STAFF RECOMMENDATION

**1914 Holly Street
March 15, 2017**

Application: New construction—detached accessory dwelling unit; Setback determination

District: Lockeland Springs-East End Neighborhood Conservation Zoning Overlay

SITE PLAN

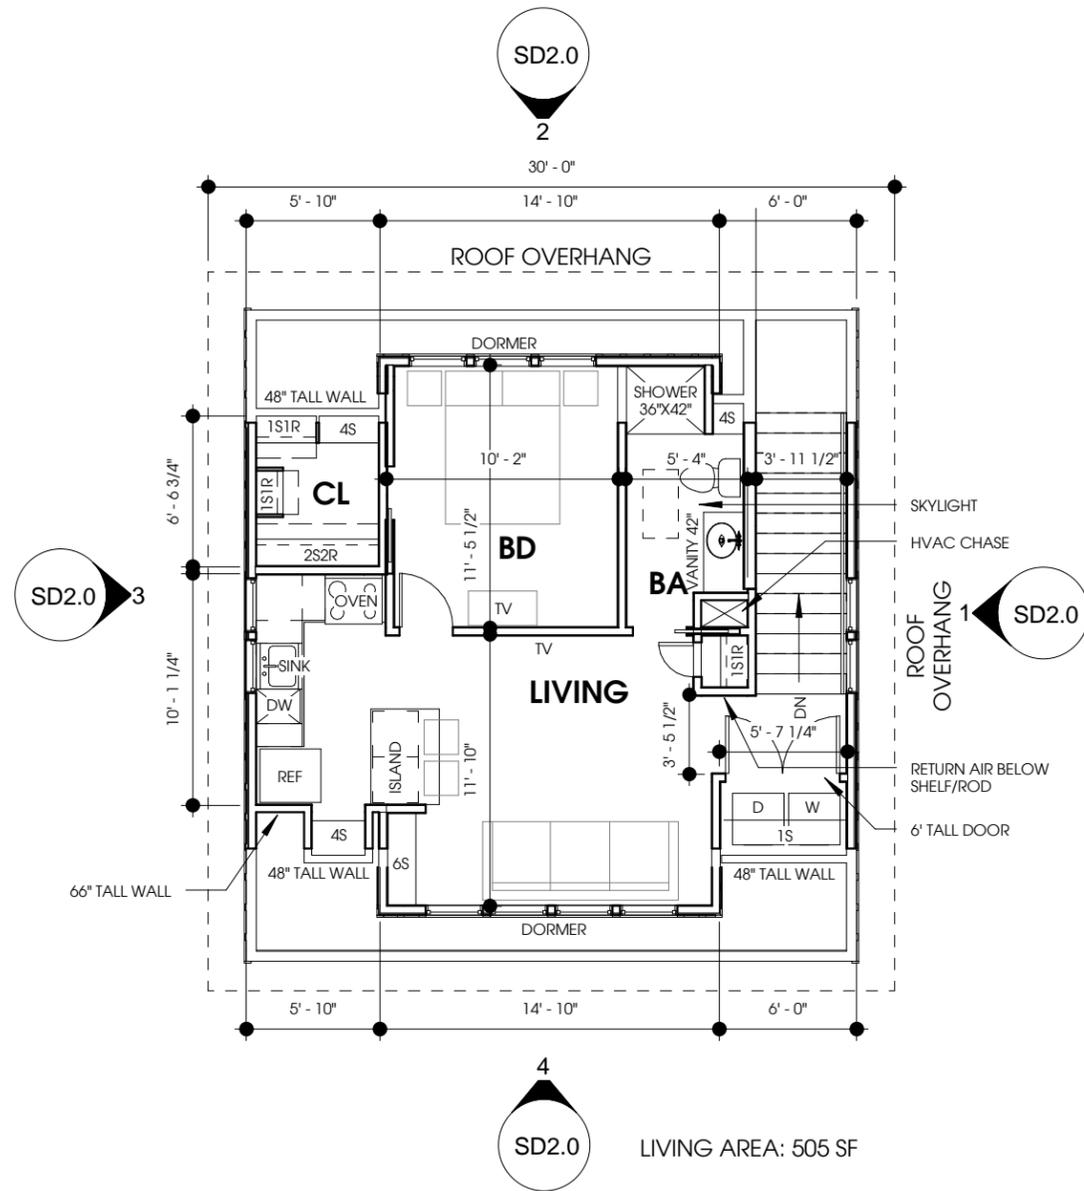
The new outbuilding does require a determination on the appropriateness of the proposed rear setback. Bulk zoning would typically require a twenty foot (20') rear setback for this building, however the applicant proposes to locate the building only seventeen feet (17') from the rear of the property. Staff finds that the shorter setback is in keeping with the location of outbuildings historically. The side setbacks are also typical of the locations of outbuildings historically, and

they meet the bulk zoning regulations. Staff finds that the project meets Section II.B.8.b of the design guidelines and section 17.16.030.G.4 of the Metro Code.

ELEVATIONS

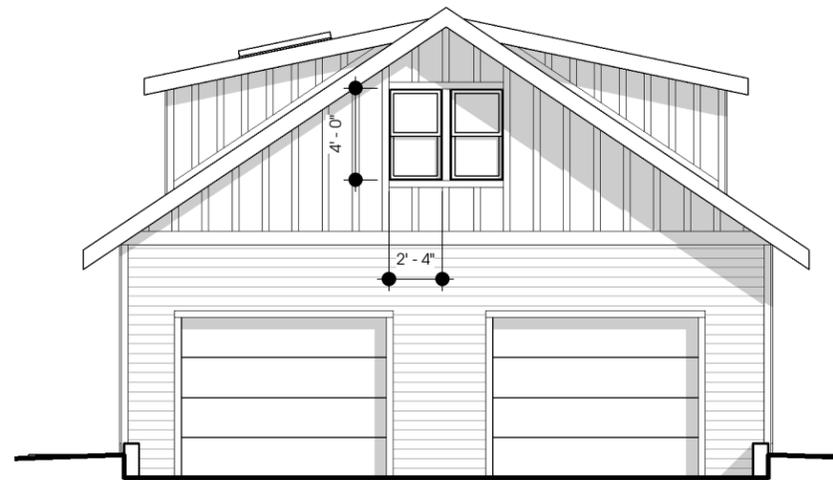
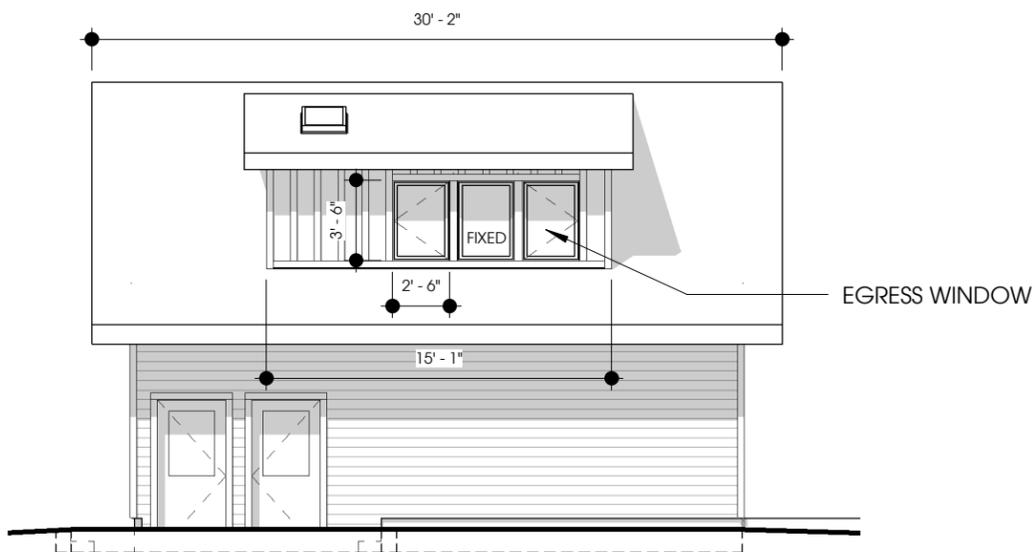
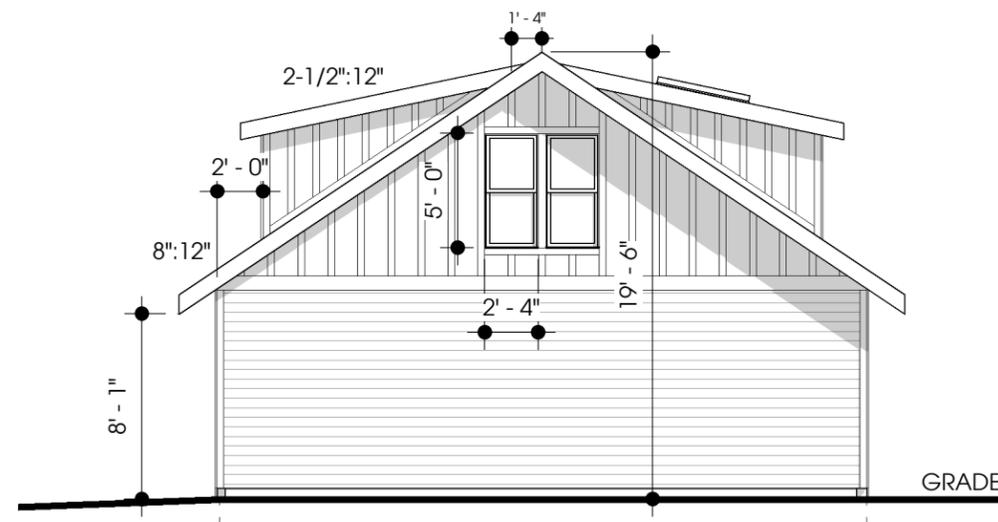
Proposed	Color/Texture	Approved Previously or Typical of Neighborhood
Foundation	Concrete slab	Typical	X
Cladding	Cement-fiber clapboard	Smooth with 5” reveal	X
Secondary Cladding	Cement-fiber board and batten	Smooth	X
Roofing	Asphalt shingle	Needs approval	X
Trim	Cement fiber	smooth	X
Porch floor	Concrete slab	Typical	X
Driveway	Concrete	Typical	X
Windows	Wood, aluminum-clad, or fiberglass-clad	Needs final approval	X
Pedestrian Door	Not indicated	Needs approval	
Vehicular Door	Not indicated	Needs approval

With the staff’s final approval of the roof color, window selection, and door selection, staff finds that the project’s materials meet Section II.B.8 of the design guidelines.
